Proposal: The applicant is requesting approval to partition a 4.35-acre parcel into two parcels of approximately 0.50 acres and 3.66 acres (21,780 sq ft and 159,429 square feet respectively) with access from the extension of NE Canter Street.

Based on the above findings of fact, and the conditions of approval, the proposed project satisfies the applicable criteria and staff tentatively approves the Partition Application No. PA 22-01, Helms-Canter Partition, pursuant to the conditions of approval listed below. A final determination will be issued after the agency/public comment period and all comments are taken into consideration.

SUBJECT: PA 22-01 - Engineering Comments

SUBJECT: PA-22-01 –Canter St NE - Residential Partition – Fire Department Comments

TENTATIVE PARTITION PLAT
STEVE HELMS
PARCEL 2, PP 2020-71
MILLERSBURG, OREGON

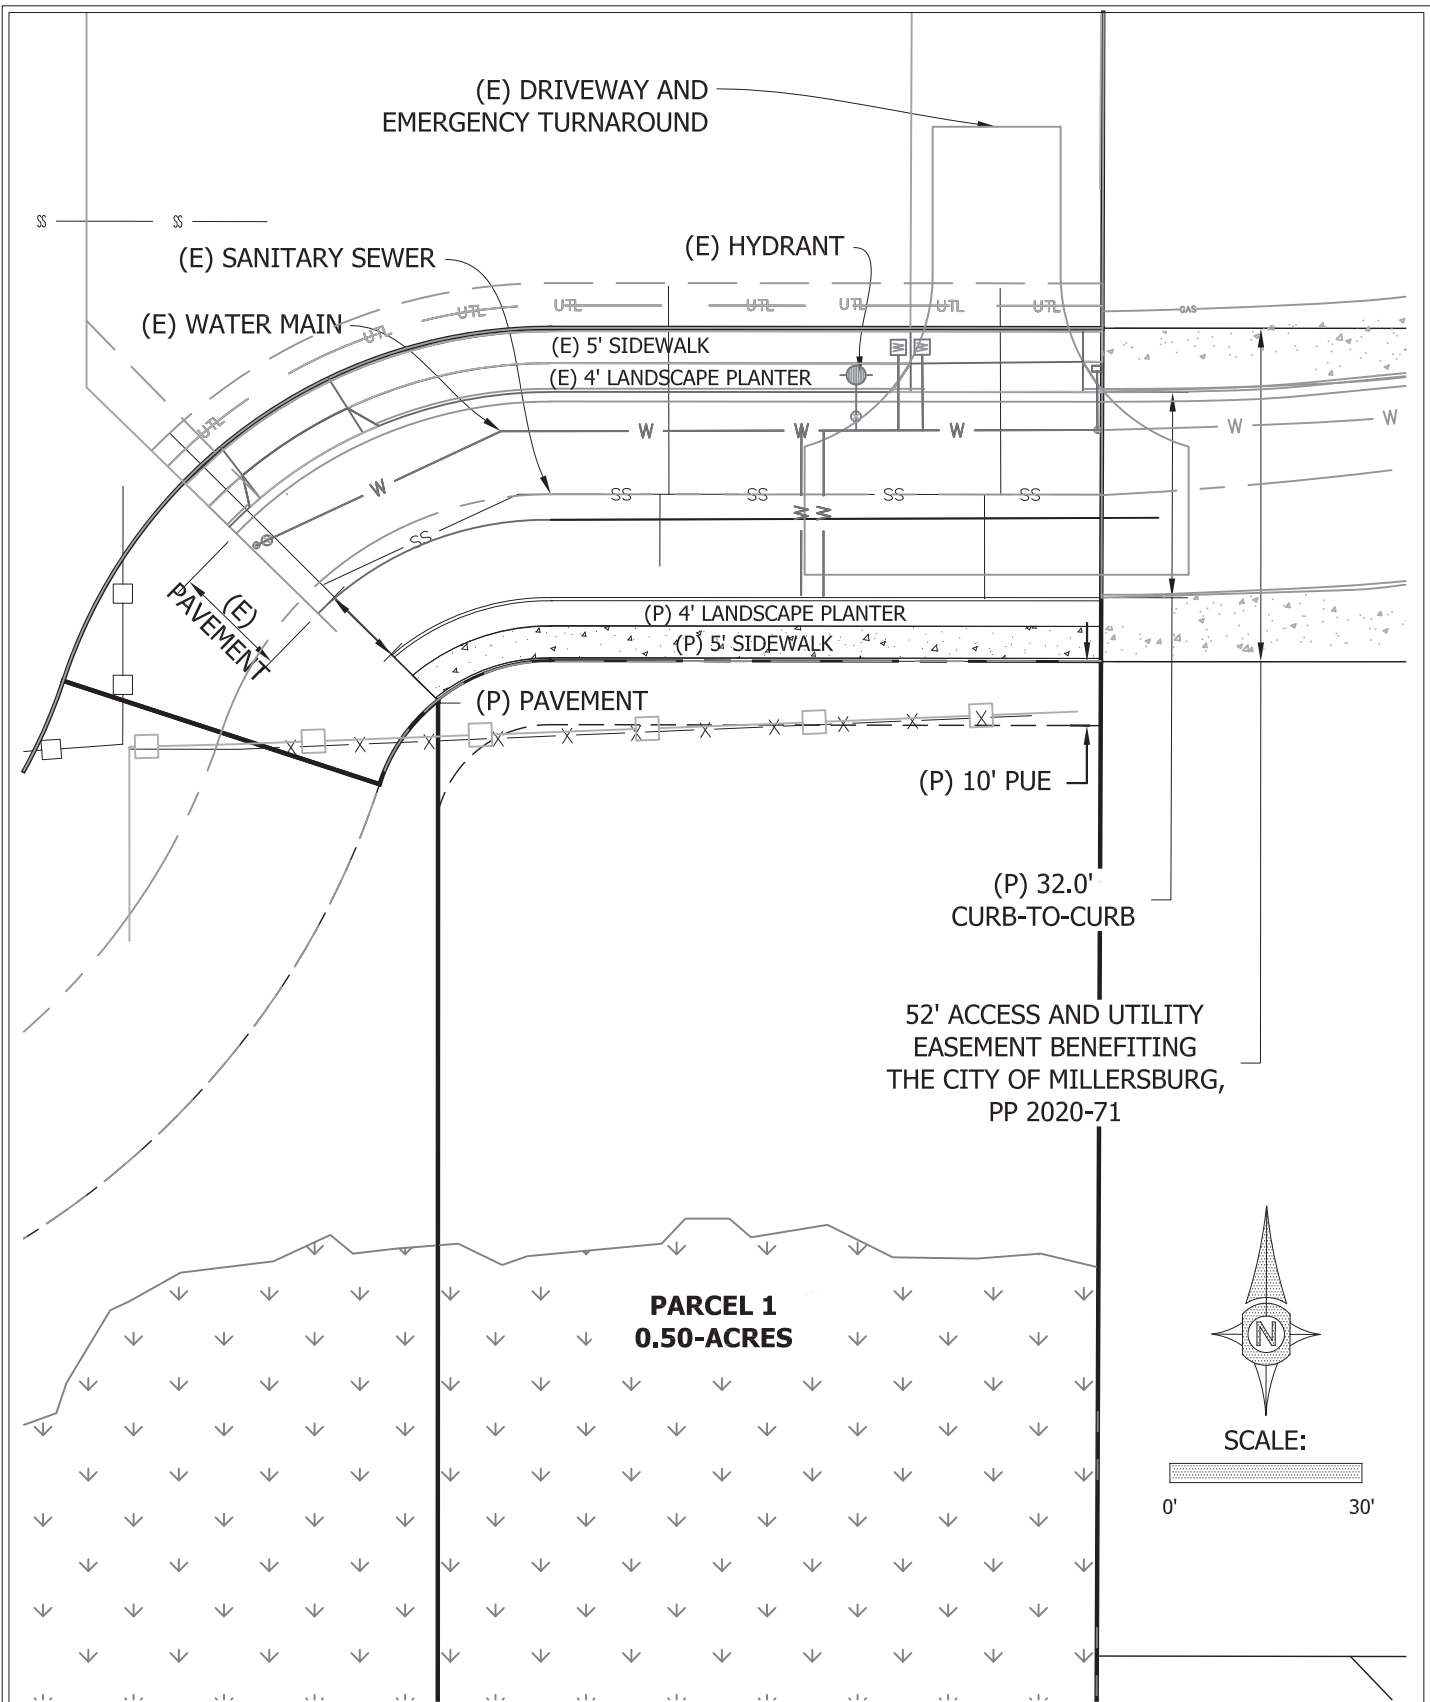
ANALYSIS: The applicant did not provide details regarding drainage. A drainage plan will need to be submitted.

ANALYSIS: The project proposes two parcels. Parcel 1 is 103 feet wide and 205 feet deep. Parcel 2 is 280 feet wide and about 520 feet long. These meet the lot to width ratio requirements. All lots feature at least 40 feet of frontage.

6. Prior to City approval of the final plat, the applicant shall provide details of all street and public utilities for review and approval. The design of Canter Ave shall complete the south half of the Canter extension that is currently under construction.

7. Prior to the City approval of the final plat NE Canter Street shall be constructed up to the end of Parcel 1 to the west.
8. Prior to City approval of the final plat, the applicant shall construct all required streets and public utilities, or provide bonding (or similar) for all improvements, to the satisfaction of the City Engineer. The applicant must have all improvements approved by the City.

- Prior to City approval of the final plat, the applicant shall submit for approval a drainage plan that meets all the requirements of the Millersburg Development Code Chapter 3.04, to the satisfaction of the City Engineer.
- Prior to City approval of the final plat, the applicant shall construct all required drainage facilities, or provide bonding (or similar) for all improvements approved by the City.
